PLANT SYSTEMS

CONDENSATE STORAGE TANK

SAN ONOFRE-UNIT 2

ATTACHMENT "B"

FIGURE 3.7.-1

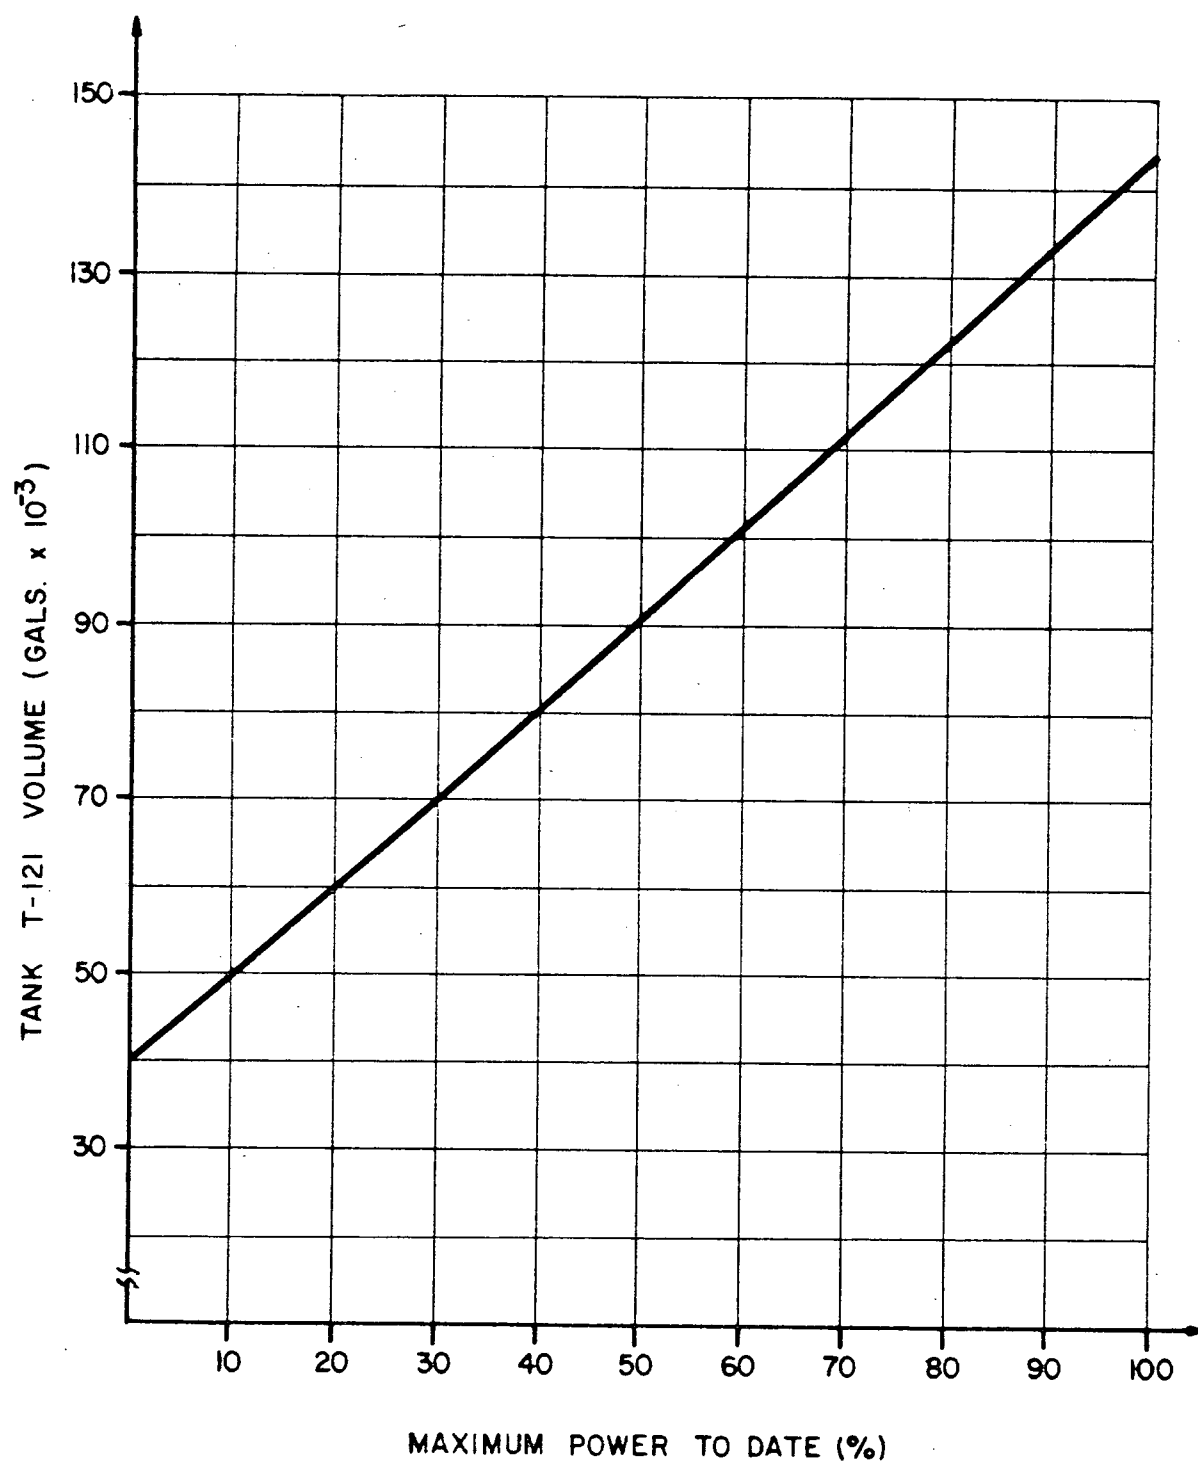
* Prior to first achieving 100% power, the minimum volume required to be contained in T-121 is that shown on Figure 3.7-1 corresponding to the maximum power level achieved to date.

3.7.1.3 The condensate storage tanks (CSTs) shall be OPERABLE with a contained volume of at least 144,000* gallons in T-121 and 280,000 gallons in T-120.
